ADDENDUM #2
NWIT-23-21
2023 New Westminster Esplanade Reconstruction
New Westminster, BC

This addendum modifies the Invitation to Tender only as noted:

2023 ESPLANADE REHABILITATION PROJECT-NWIT-23-20

PLAN - BENTS 31-60
1:200

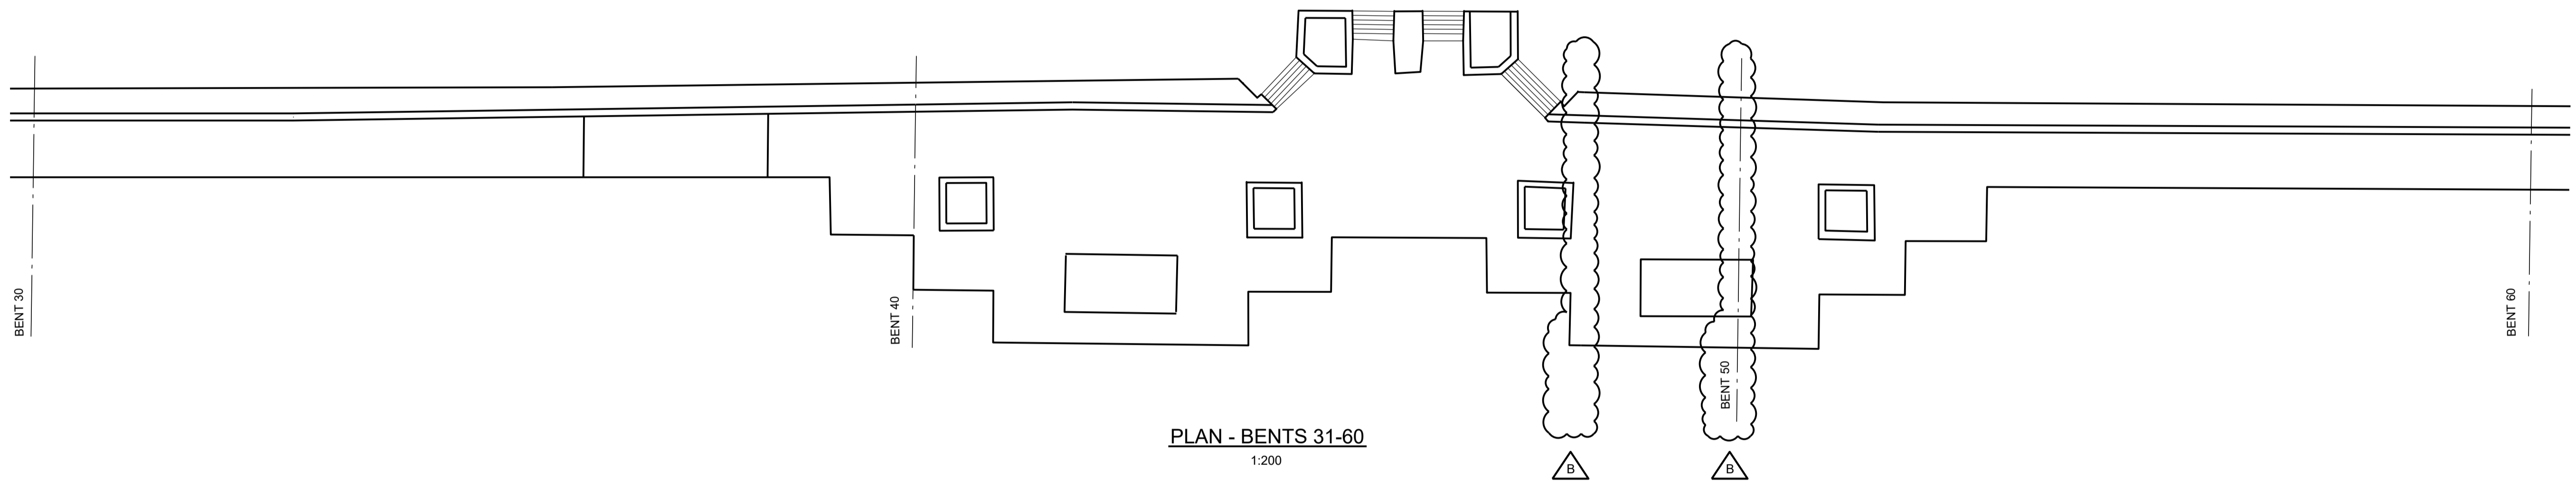
- Q4 Bent 50 on sheet 3 does not line up with existing bent 50 “tags” nor does it add up when counting on the drawing from bent 40. Could you confirm which is correct as pile caps 52 and 53 are scheduled for replacement?

- A4 Refer to the updated Drawings attached to this Addendum. Location of Bent 50 has been updated in the drawings.
- Q5 Please confirm which lumber treatment is acceptable:
CCA.40 Incised
CCA.60 Incised
ACZA 40 Incised
ACZA 60 Incised
ACZA .1.9 Incised
Supplier has indicated that the creosote plant is not taking on anymore work.

FIGURE 5

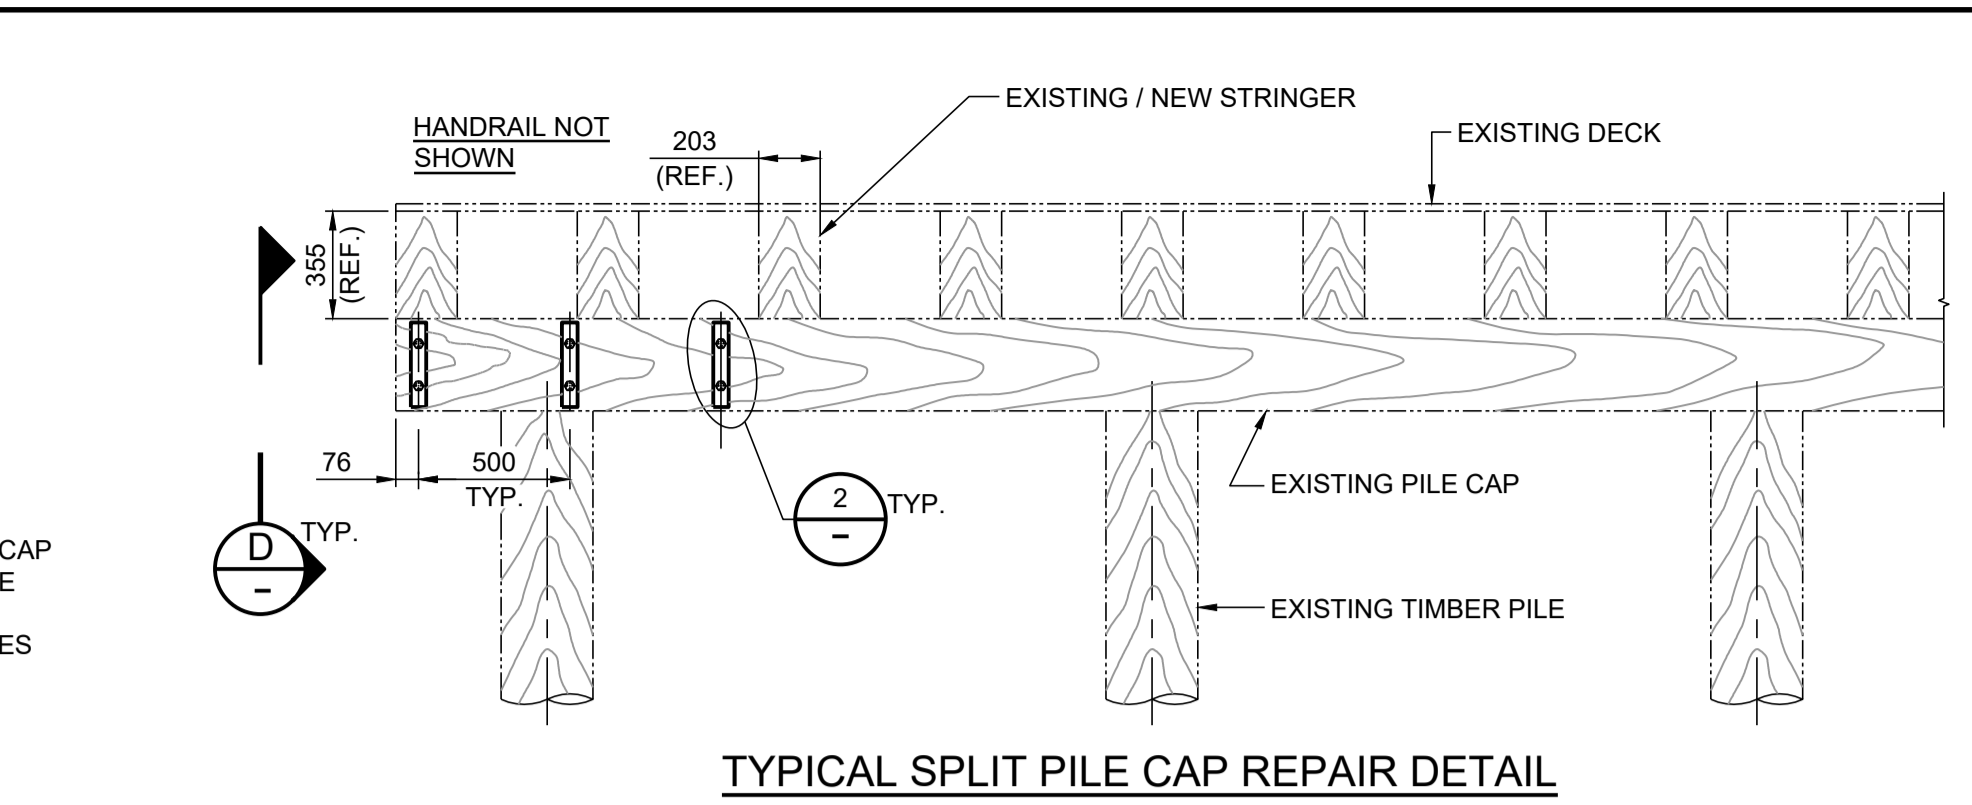
Q10 Drawing No. 5 – Summary of repairs: The notes on this sheet (note 2 at the bottom right side) state that 4" x 4" x 16' timber cross bracing members have been procured by the city. Contractors shall coordinate with the Engineer for pickup location and date/time. Where are these cross bracings to be used? Figure 5 indicates that cross bracings are of a different size (4" x 6", not 4" x 4").

A10 4" x 4" x 16' timber is not part of this scope. The City has the following timber members for the project. The contractor will supply any additional timbers required for the project.
Full dimension 4 x 6 x 16' = 24 each
Full dimension 12 x 12 x 16' = 5 each

FIGURE 6

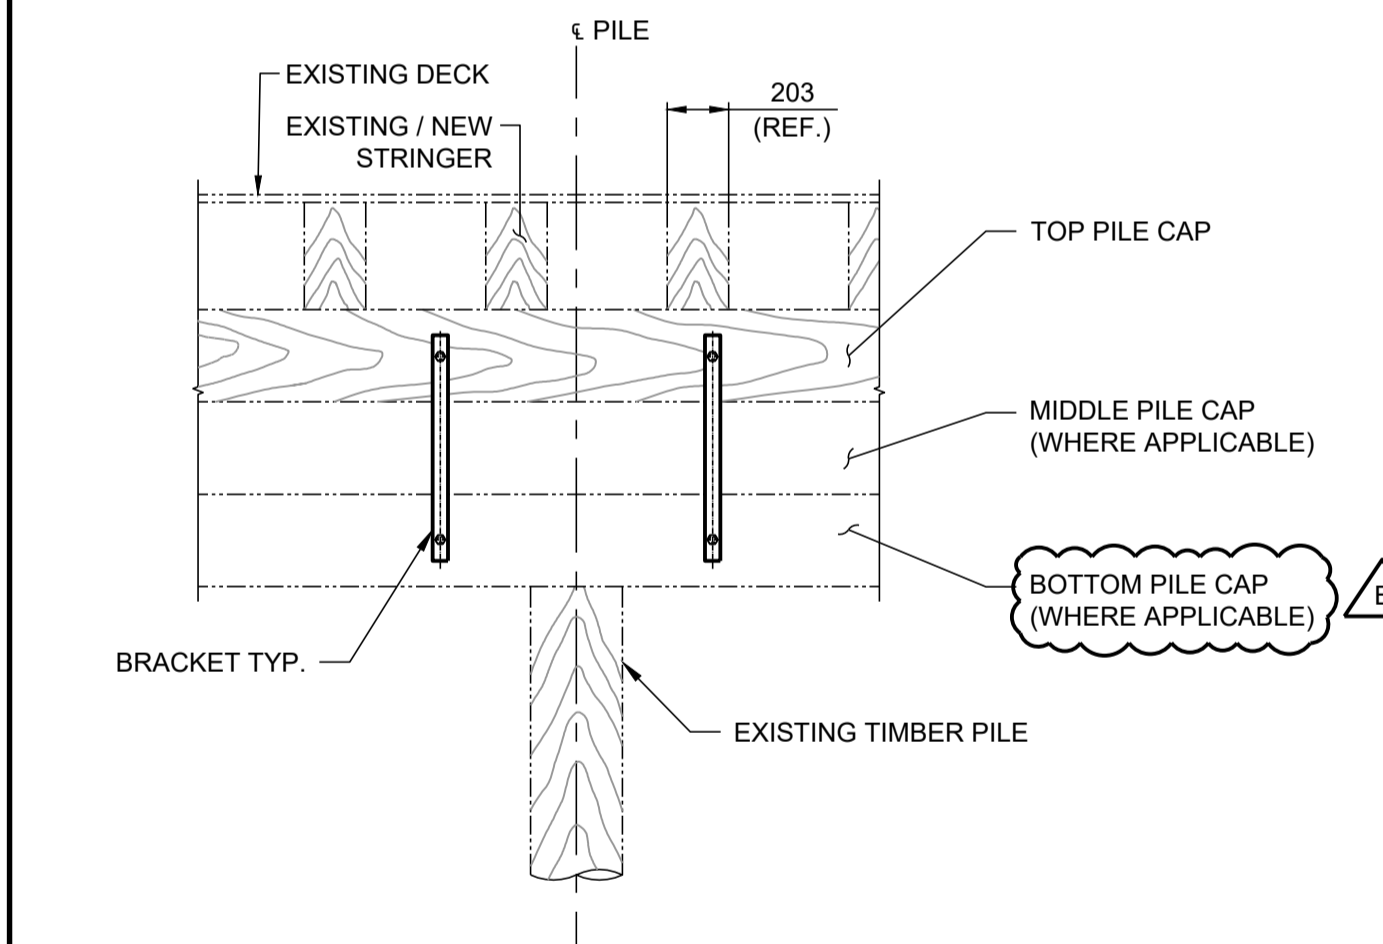
- A5 Either ACZA.60 or CCA.60 shall be used.
- Q6 Over-size timber: Are these items glulams or just held together with the brackets?
- A6 Refer to the updated Drawings attached to this Addendum. These are held together with brackets. Figure 6 for oversized cap connection details.

FIGURE 7

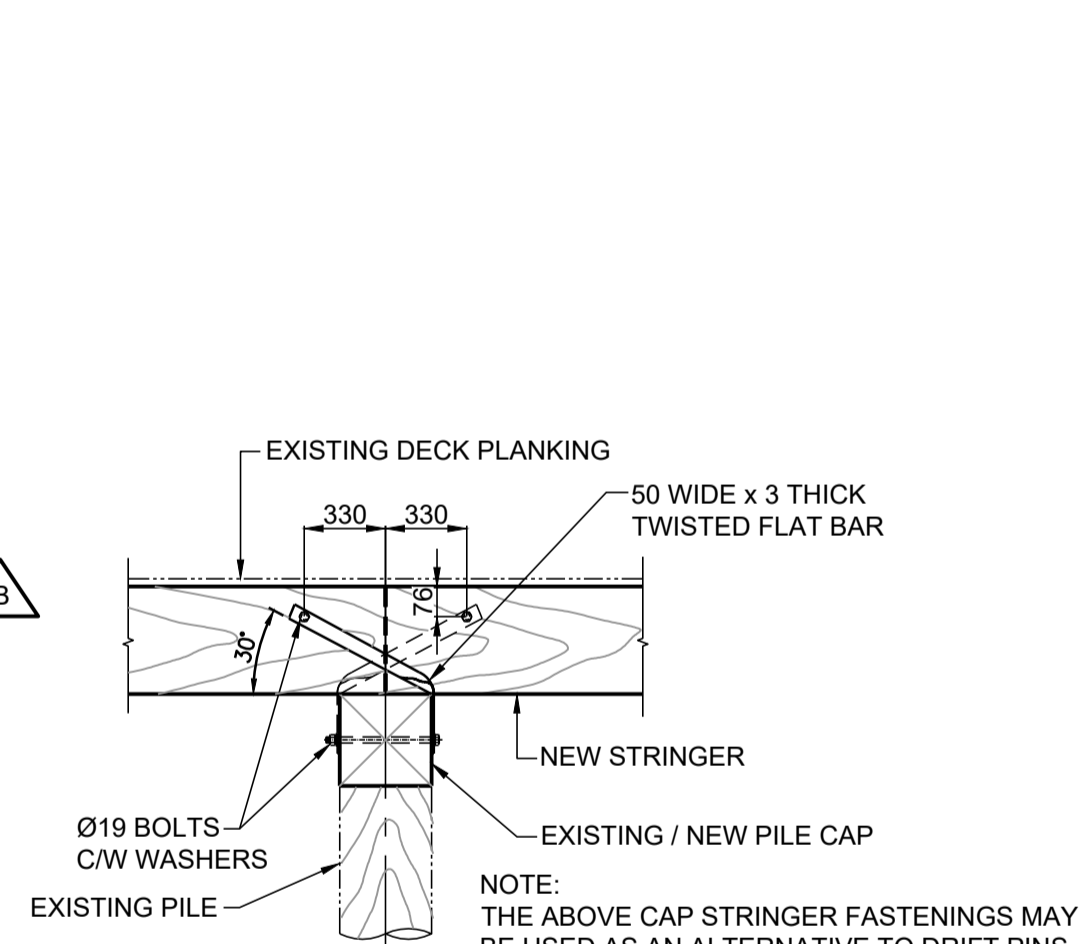
Q9 Stringer Replacement: Figure 7 was provided for stringer replacement. However, no stringer replacement was included in the summary of repairs or in the schedule of quantities and prices. Please clarify if stringers are to be replaced, their locations, sizes, and quantities.

A9 At present, no stringers are to be replaced. However, in the event that a replacement is identified to be needed during construction, the Figure 7 detail will be utilized.

FIGURE 8

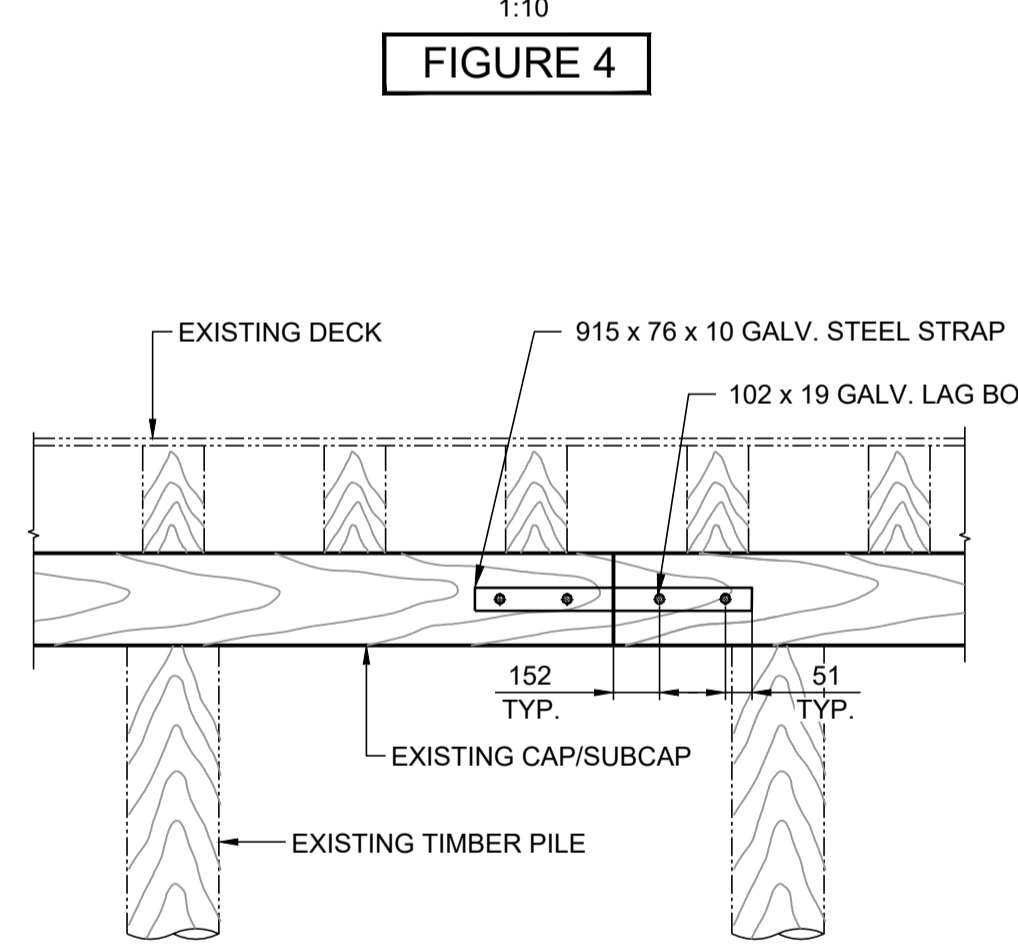
- Q8 Pile Banding: Figure 8 is stated as detail for Pile Banding. The figure however does not seem to represent the said repair. Please clarify “pile banding”.
